PLANNING DIVISION STAFF REPORT

May 11, 2020

Project Address: 1109-1123 S Park St. (District 13 – Ald. Evers)
Application Type: Demolition Permit and Conditional Use
Legistar File ID # [59543](#)
Prepared By: Chris Wells, Planning Division
Report Includes Comments from other City Agencies, as noted
Reviewed By: Kevin Firchow, AICP, Principal Planner

3 North West Elevation
A-2.2 1/8" = 1'-0"

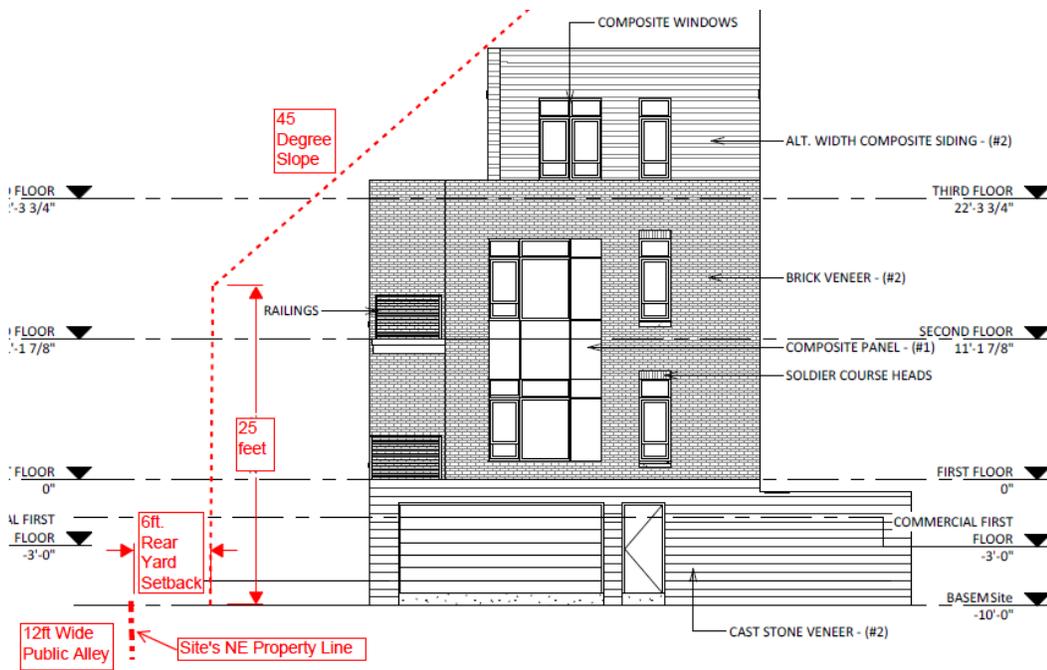
Regarding Standard 12, Staff note that for the TSS District, the maximum height (allowed without a Conditional Use approval) is three stories or 40 feet. While the proposed building meets the three-story limit, it exceeds the 40-foot limit with an average elevation height (for the entire building) of roughly 43 feet. The building's S Park Street elevation is almost exactly 40 feet tall, with the extra height resulting from the roughly five- to seven-foot drop in grade moving northeast across the site from S Park Street.

Furthermore, as noted above, in order to reduce the overall impacts of the building's height, mass, and bulk on the adjacent one- and two-story single-family development, the applicant has not only situated the building on the front half of the project site, along the public sidewalk, but also stepped back the third floor massing – roughly 14 feet at the northern corner to create a shared roof terrace, and roughly nine feet at the northeastern corner to create a shared patio for the two adjacent units.

Staff note that the height transition ordinarily required for buildings where abutting residential districts in the TSS District does not apply in this case due to the public alley which separates the subject site from the immediately adjacent lot. However, if this transition requirement *did* apply, the below graphic shows that proposed building would comply with setback and stepback regulations. In order to *voluntarily* comply with this TSS District's height transition requirement, the applicant has pulled the building back from the northeastern property line nearly 19 feet – over three times the required rear yard setback (i.e. six feet).
